III. CORRECTIONS AND ADDITIONS TO THE DRAFT EIR

INTRODUCTION

Figure 5
Vehicular Circulation Plan

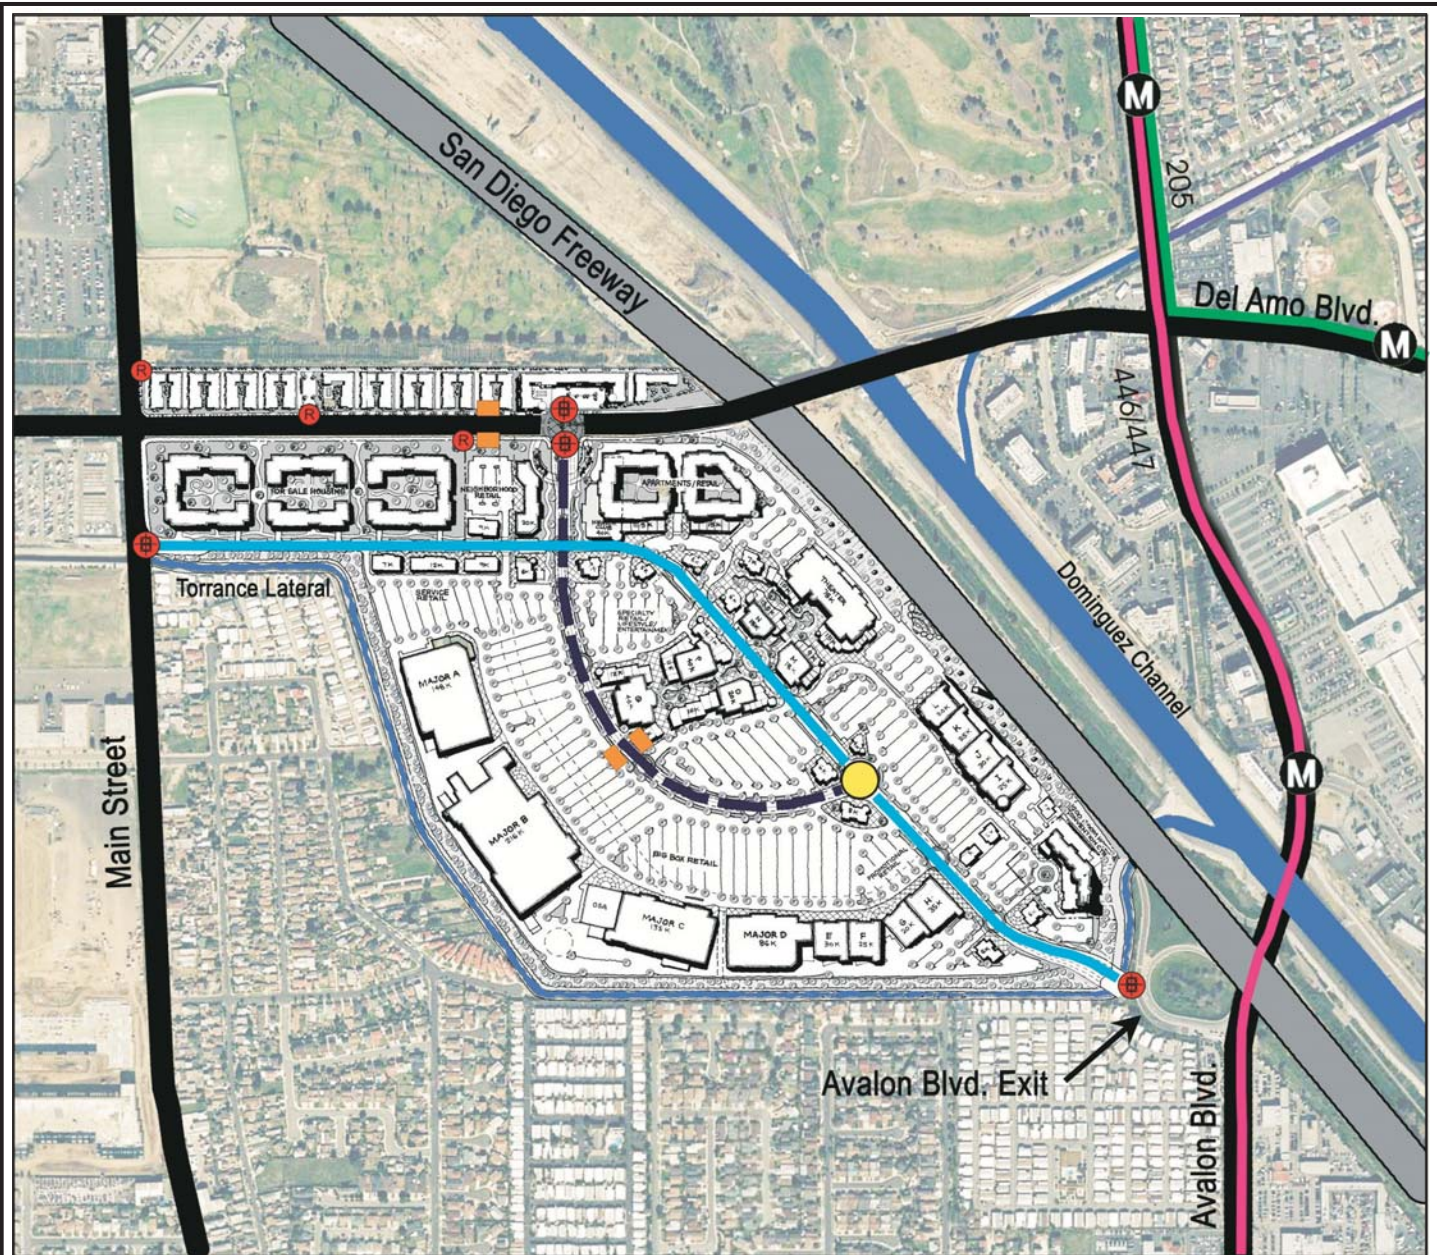
- f. Volume I, Section II., Project Description, page 86, Figure 5. Replace Figure 5, Vehicular Circulation Plan, with the revised Figure 5, as shown on page 106.
- g. Volume I, Section II., Project Description, page 90, Figure 7. Replace Figure 7, Landscape Plan, with the revised Figure 7, as shown on page 107.
- h. Volume I, Section II., Project Description, page 97, top of page. Re-designate the heading to read “E. SITE REMEDIATION.” Replace the first sentence under the heading with the following:

Figure 32
Liquefaction Hazard Zones

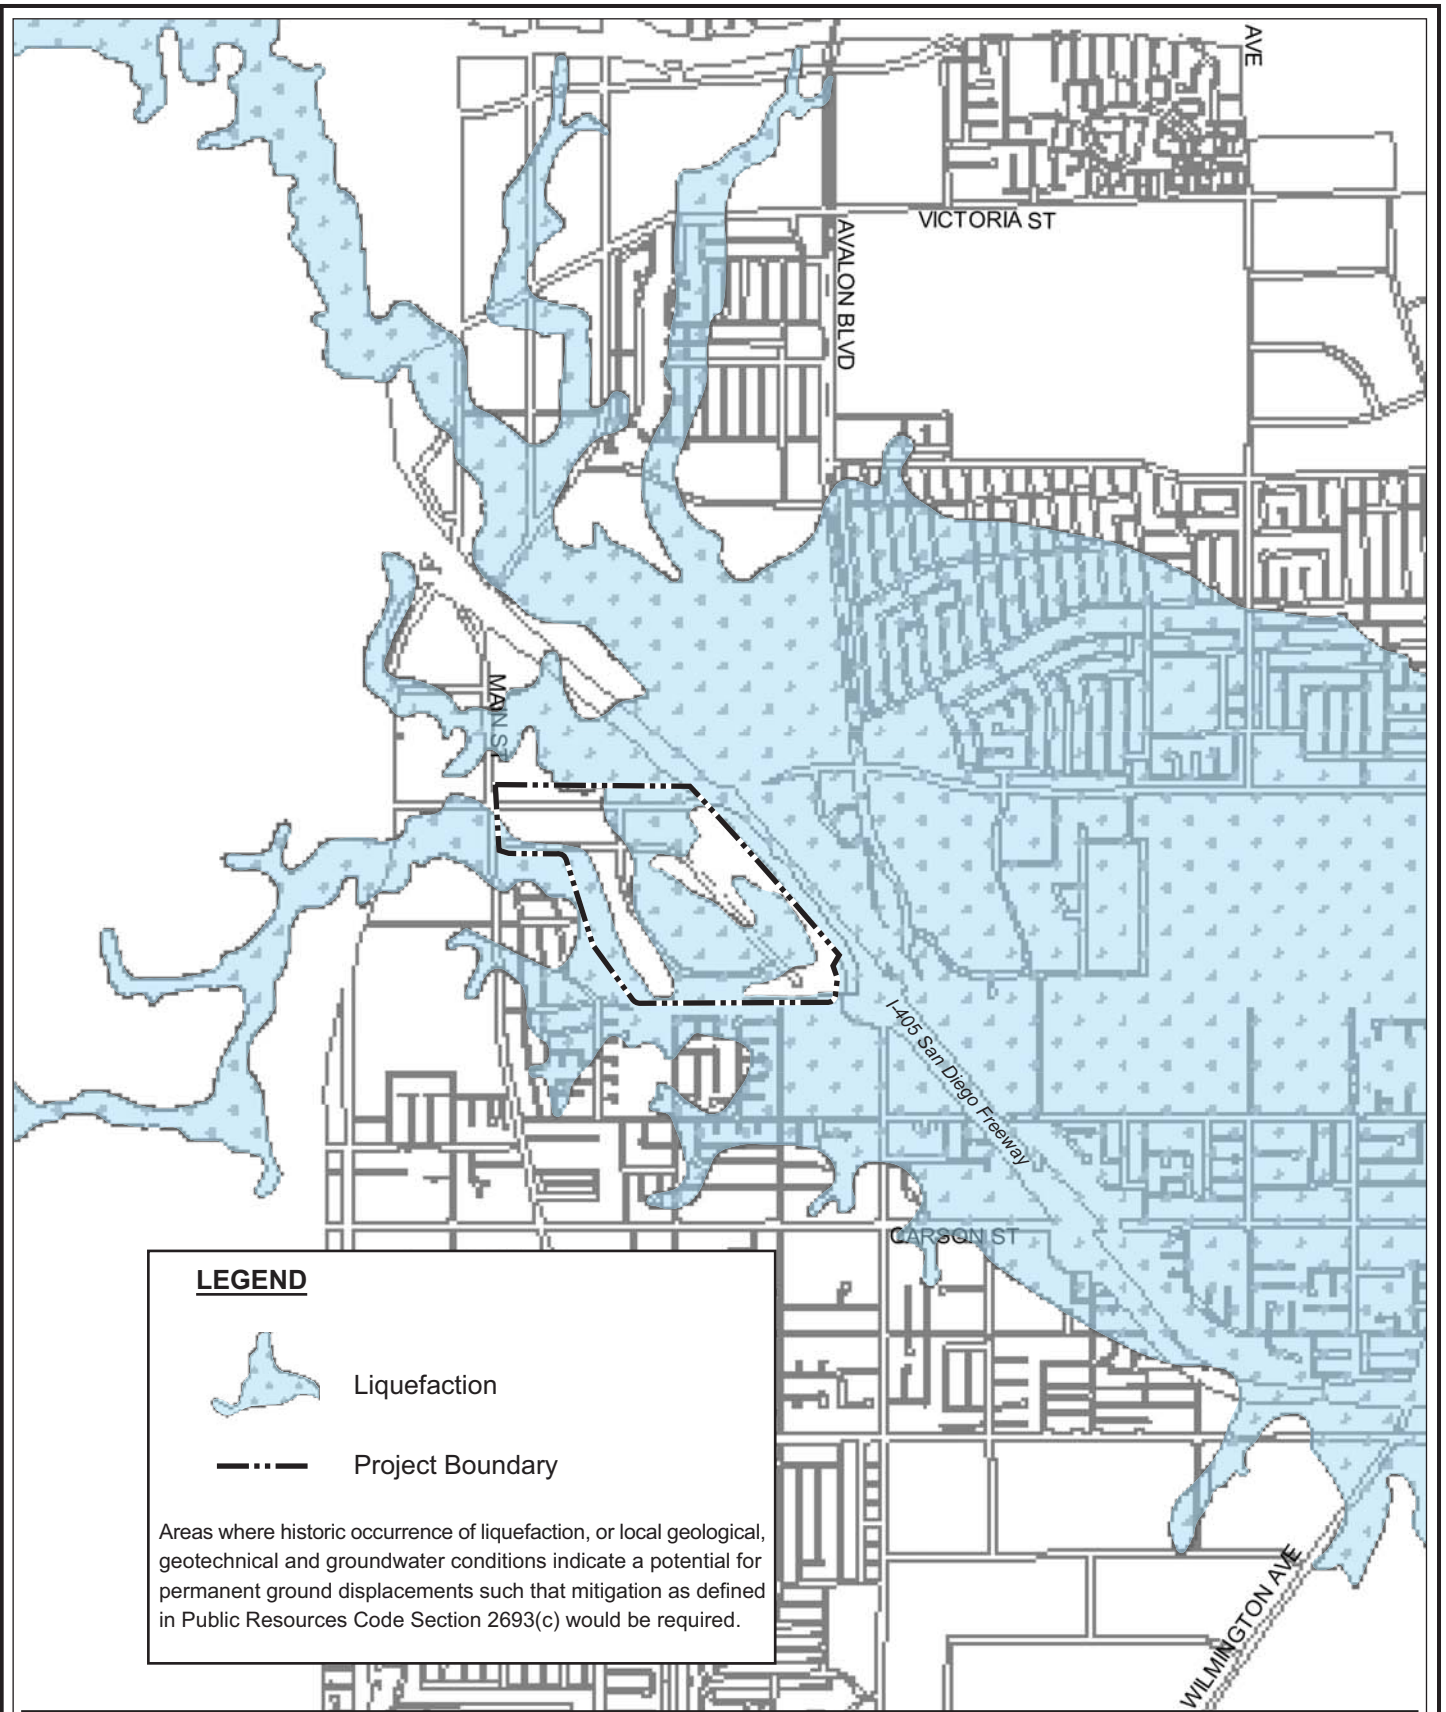
- a. Volume I, Section E, Geology and Soils, page 314, last paragraph. “Change “Chapter 33” to Chapter “34.”
- b. Volume I, Section E., Geology and Soils, page 324. Replace Figure 32 with the revised version, as shown on page 111.
- c. Volume I, Section E, Geology and Soils, page 326, 3rd paragraph [paragraph c.(1). Revise the first sentence to read:
